Process Sheet

: CU-DAR001 Dart Helicopters Services

: D3560042 . D3560 REV D

Subject: RE: D3560-044 & -042 Cracking

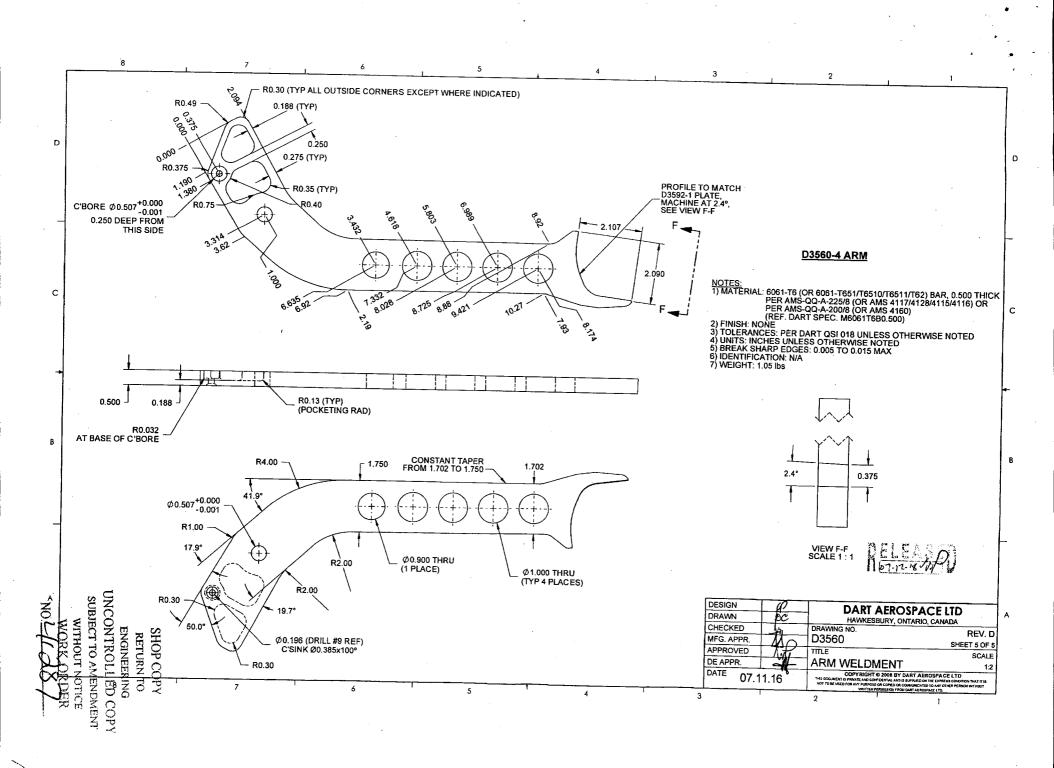
We have 13x D3560-044 and 1x D3560-042 that have cracks all but 1 in the same location. Attached image D3560-044 Crack 1 shows where 13 of the 14 cracks occurred. D3560-044 Crack 2 shows where the other crack occurred. The cracks shown in D3560-044 Crack 1 vary in depth from roughly 3/32 to ½ inch. I discussed this with Chris and Peter the consensus opinion is the parts are scarp. Further discussion with Chris indicates that changing grain direction to 45 degree on the sheet metal part may lower the scrap rate but not eliminate it. This has been done on a previous deviation with a less scrap. D3560-044 Crack 2 appears to just be an anomaly.

I am not comfortable with any sort of repair to these parts.

I think that all 14 parts should be scrapped.

And, at the risk of stating the obvious, we need to revisit the manufacturing process of this joint.

My preference, as it was a couple of years ago, is to eliminate this weld.

However, the geometry in that area is a little tricky. Suggest we generate an NCR or PAR or whatever.
